3260 FLORIN RD.

S21192
FILE COPY

Kia Motors America, Inc.

STANDARD PS-4 INSTALLATION DETAILS.

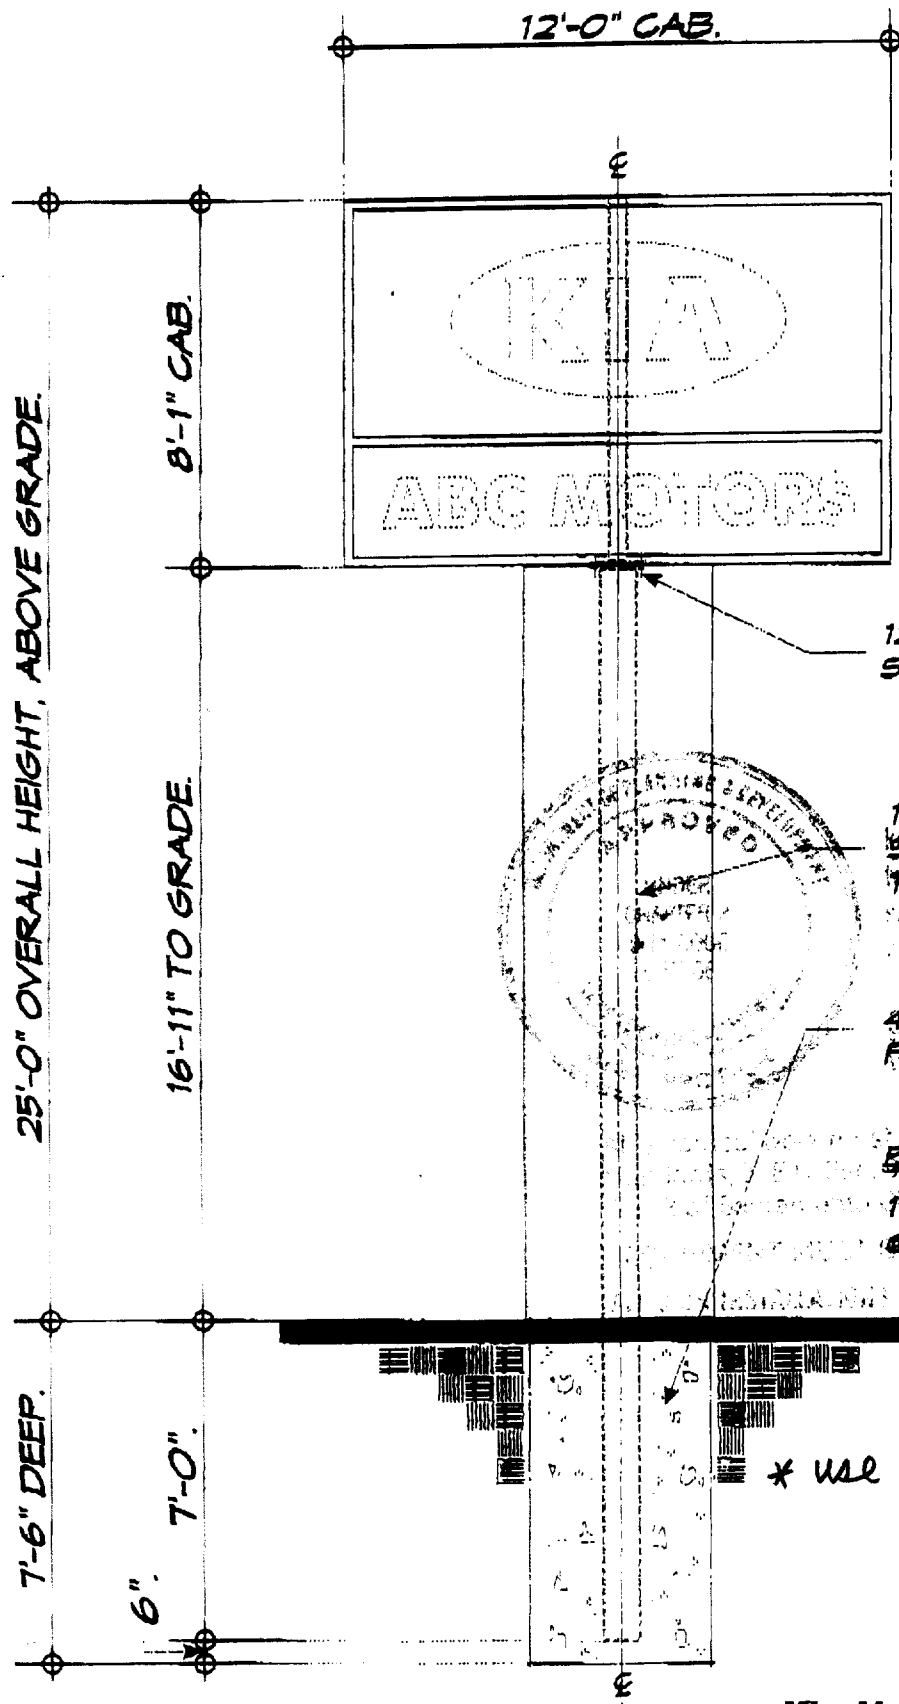
Provide Disconnect

* use min. 5 sacks of cement
